OAK RIDGE LEVEL II RESERVOIR DAM NJ 00014

PHASE 1 INSPECTION REPORT NATIONAL DAM SAFETY PROGRAM.

Oak Ridge Reservoir Dam (NJ 00014).
Passaic River Basin. Pequannock River,
Morris County, New Jersey.
Phase I Inspection Report.

Deterioration of spillway concrete.

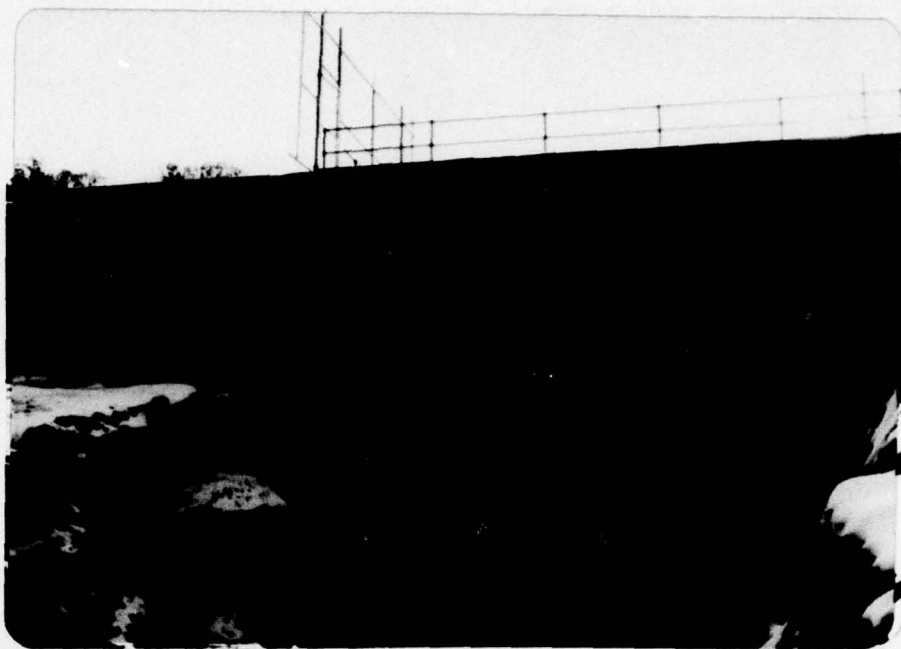
Deterioration of spillway concrete.

Deterioration of concrete at spillway
left sidewall.

(1) The open joint and spalled and cracked concrete on the spillway weir should be repaired.
